Alterations to Gymnasium and Classroom Buildings at Burnt Ranch Elementary School Mold and Rehabilitation Project- Electric MSB- Bid Package 2018.4.5 Scope Clarification 2

BURNT RANCH ELEMENTARY SCHOOL
ALTERATIONS & ADDITION TO MULTI-PURPOSE
BUILDING/ CLASSROOM - INCREMENT 2

BID PACKAGE
CLARIFICATION

E0.2-I2

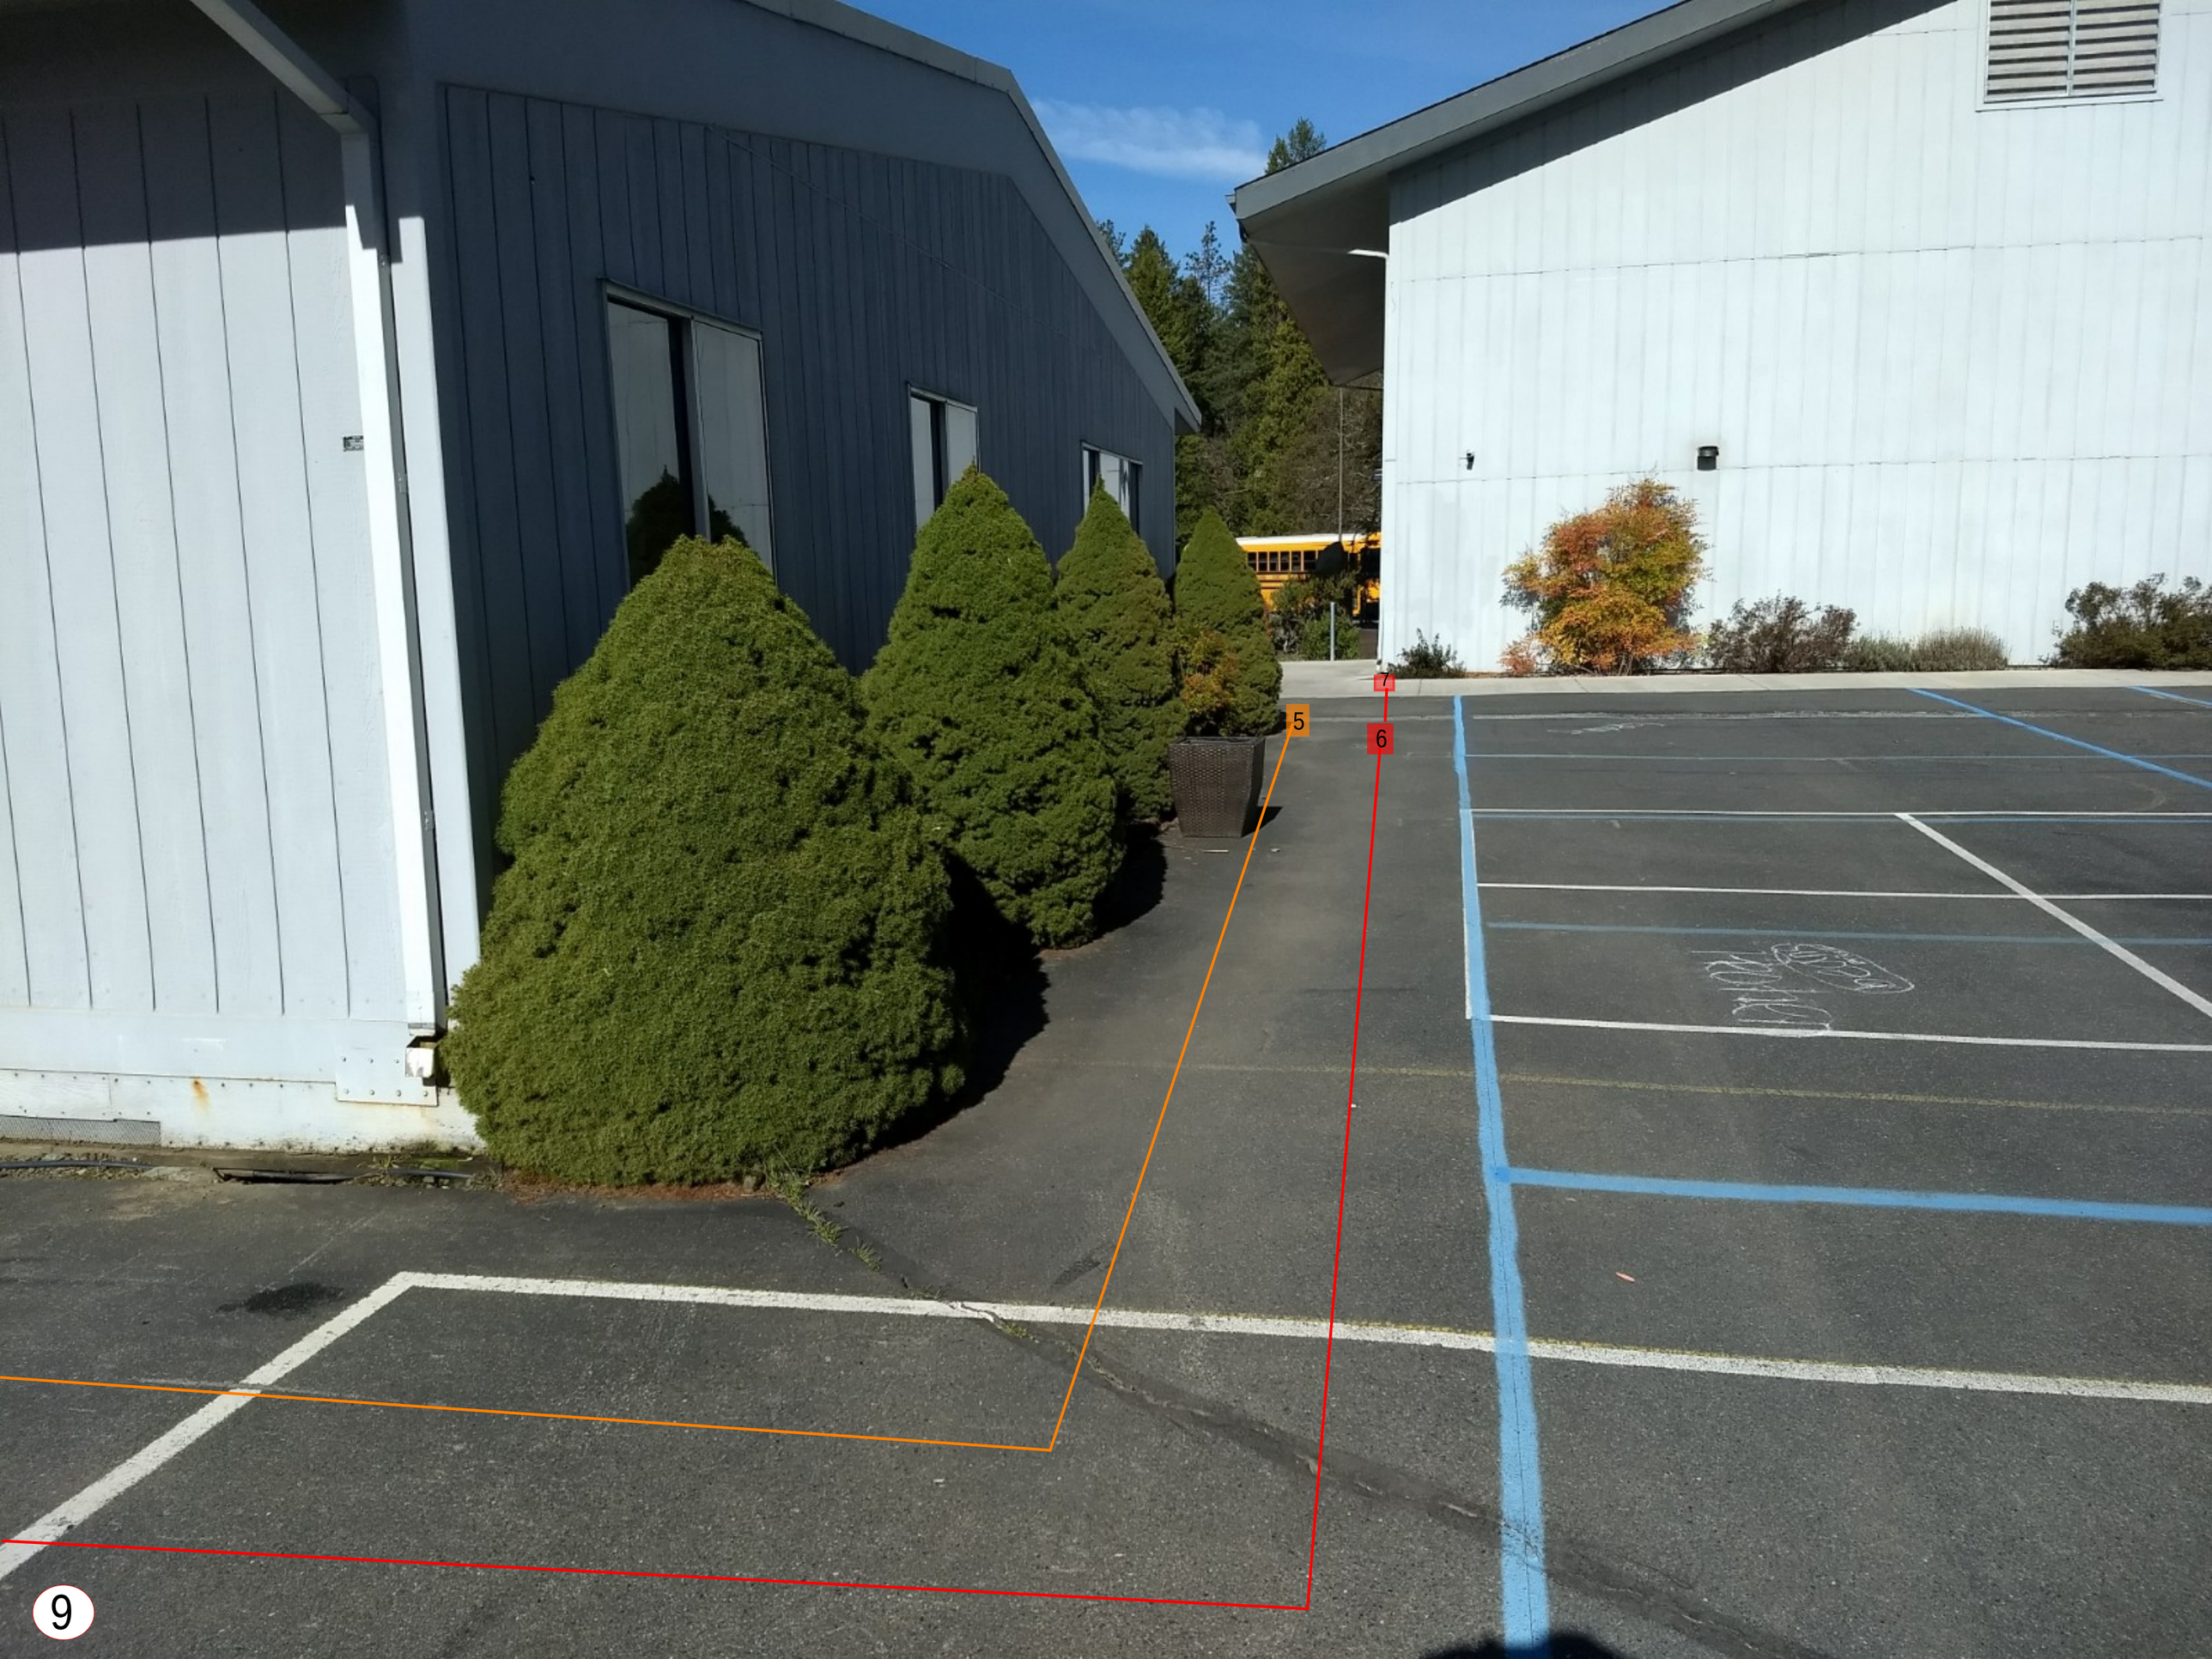
Contractor shall intercept and splice tap (N) to (E) conductors .
7
6
5
